PLAN OF PROPOSED IMPROVEMENT

STRICKER POND FOREBAY DREDGING

CITY PROJECT NO. 15697
CONTRACT NO. 9657

15697
 U-2

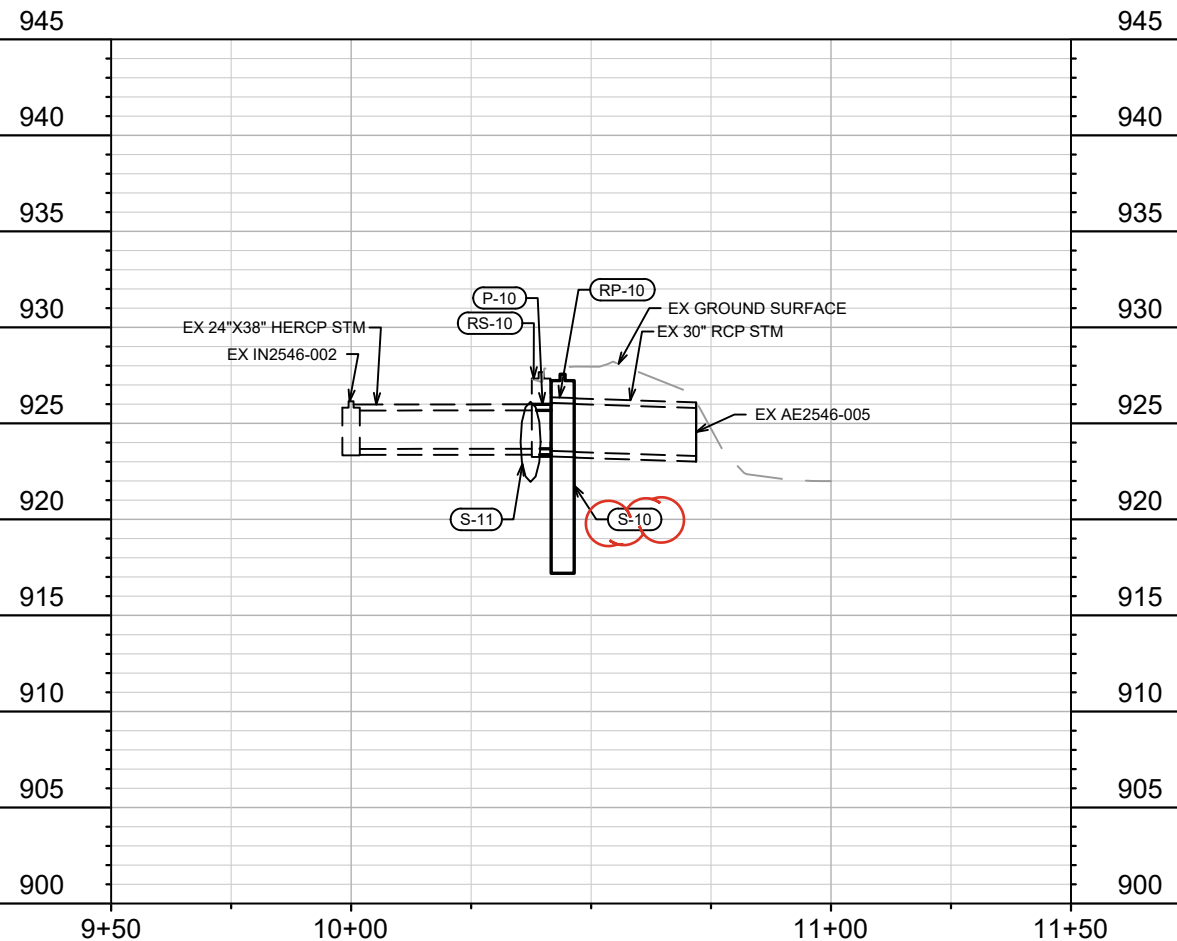
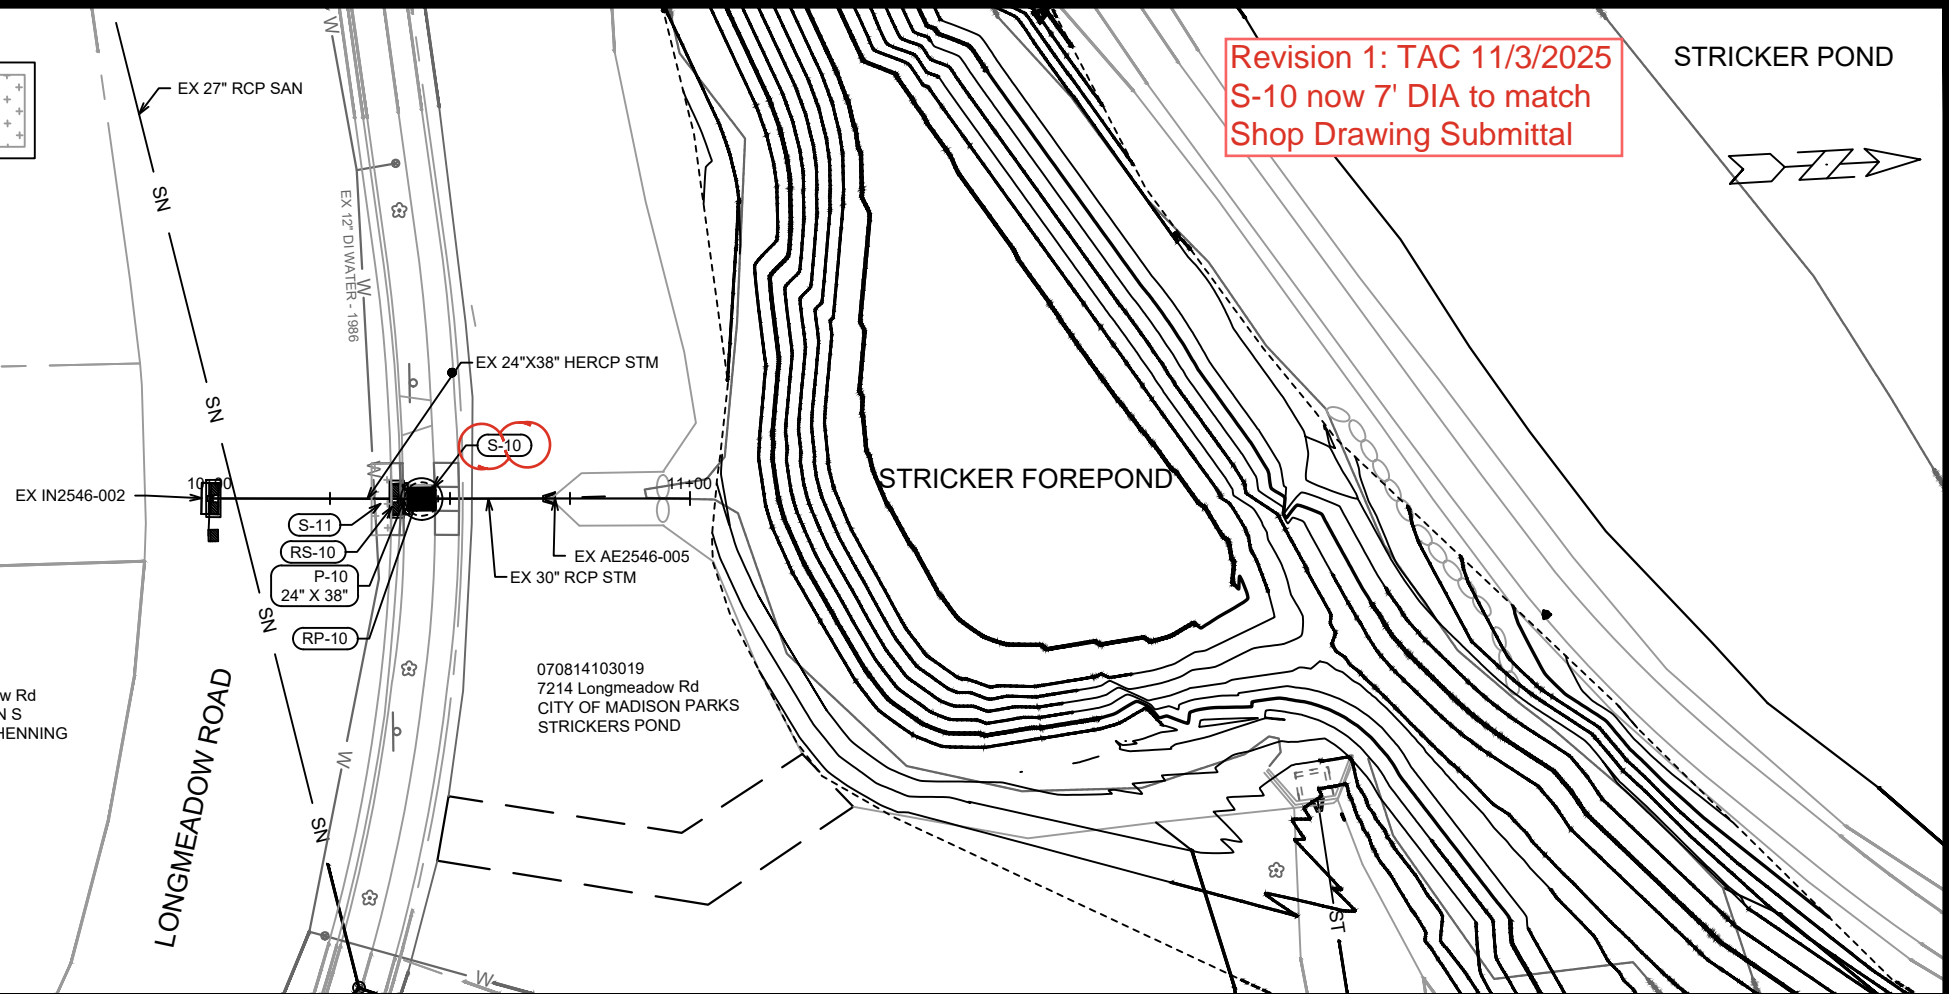
Revision 1: TAC 11/3/2025
S-10 now 7' DIA to match
Shop Drawing Submittal

Revision 1: TAC 11/3/2025
 S-20 now 5' DIA & Type 3 to
 match Shop Drawing Submittal.
 Insertion point changed

15697
 U-4

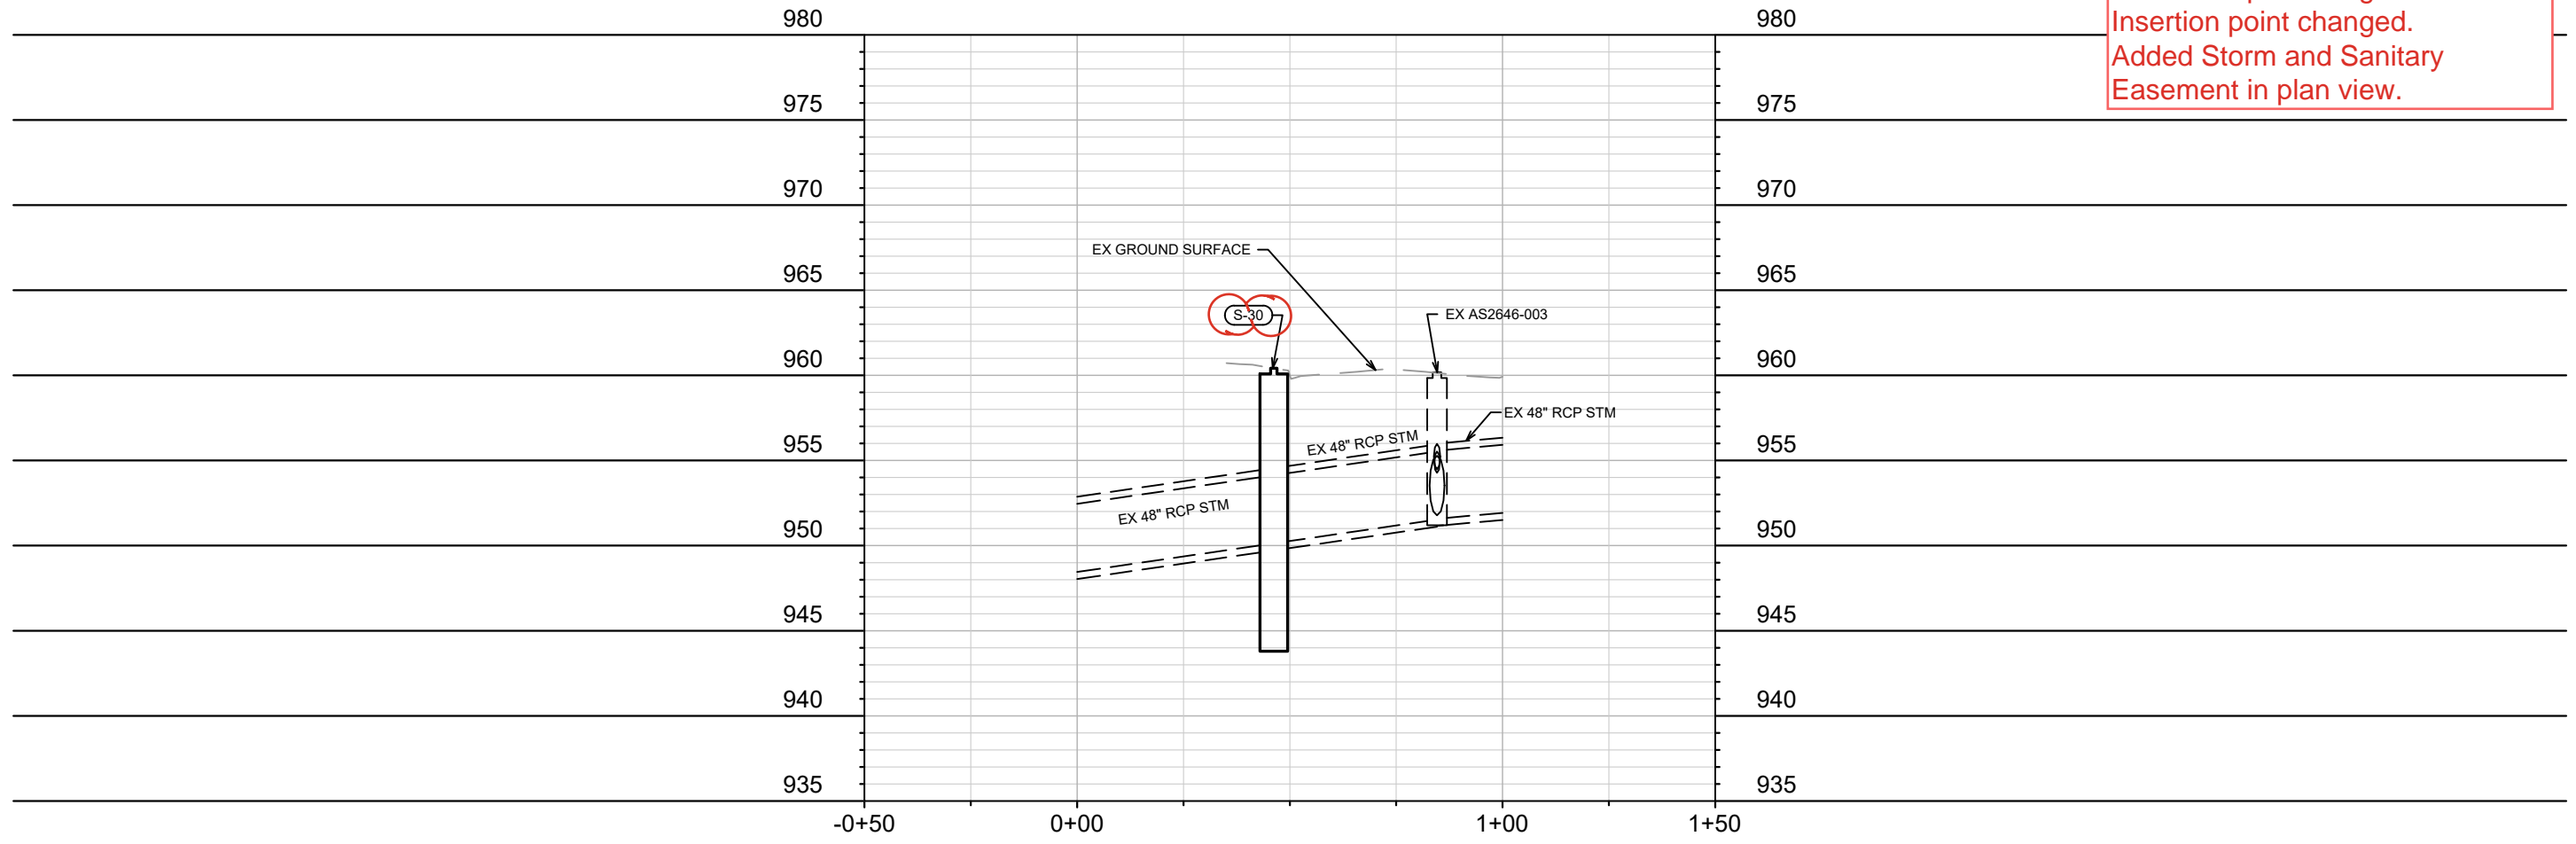
Revision 1: TAC 11/3/2025
S-30 now 7' DIA & Type 3 to match Shop Drawing Submittal.
Insertion point changed.
Added Storm and Sanitary Easement in plan view.
